UNITED STATES PATENT AND TRADEMARK OFFICE

APPLICATION NO.	FILING DATE	FIRST NAMED INVENTOR	ATTORNEY DOCKET NO.	CONFIRMATION NO.
10/817,184	04/02/2004	David L. Linam	AG10031083-1	2153
22878	7590	03/14/2006	EXAMINER	
AGILENT TECHNOLOGIES, INC. INTELLECTUAL PROPERTY ADMINISTRATION, LEGAL DEPT. P.O. BOX 7599 M/S DL429 LOVELAND, CO 80537-0599			LAM, TUAN THIEU	
			ART UNIT	PAPER NUMBER
			2816

Office Action Summary

DETAILED ACTION

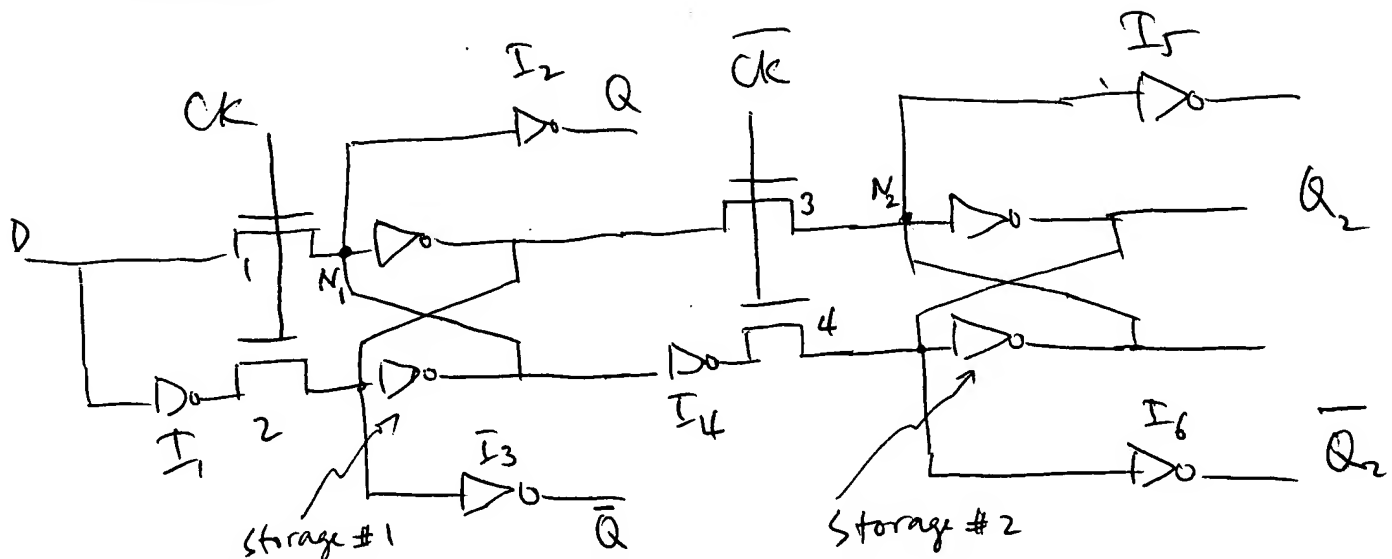
Below is the detailed arrangement of the combination of Olisar et al. and JP 5-37305 references. The combination of reference comprises an input signal (D), a first pass gate (1), a first storage node (N1), a second pass gate (3), a first inverter (I4), a third pass gate (4), an unclocked second storage node (N2) as called for in claim 9.

Regarding claim 10, the combination of references shows a second inverter (I5) and a third inverter (I6).

Regarding claim 11, the combination of references shows the first storage node comprises two inverters.

Regarding claims 13, the combination of references shows the second storage node comprises two inverters.

Regarding claim 12, the combination of references shows fourth and fifth inverters (upper and lower inverters of the storage nodes) but does not disclose the sixth inverter is weaker than the fourth inverter. However, it is known to have the upper inverter of the master stage bigger than the upper inverter of the slave stage in order to overcome the signal of the subsequent stage (slave stage) thus preventing erroneous operation. Therefore, outside of an non-obvious results, the obviousness of having inverters of different size will not be patentable under 35USC 103(a).

Regarding claim 14, the combination of references shows does not disclose the fourth inverter (upper inverter of the second storage node) is weaker than the first inverter (I4).

However, it is known to have the input inverter bigger than the inverters of the storage within the master or slave flip flop in order to overcome the signal within the latch thus preventing erroneous operation. Therefore, outside of an non-obvious results, the obviousness of having inverters of different size will not be patentable under 35USC 103(a).

Regarding claims 15-16, since the first and second storages are not clocked storage, therefore, the stored input data and the inverted stored input data conveyed to the true and complement output nodes (Q2, Q2/) regardless of states of the master clock signal and the slave clock signal.
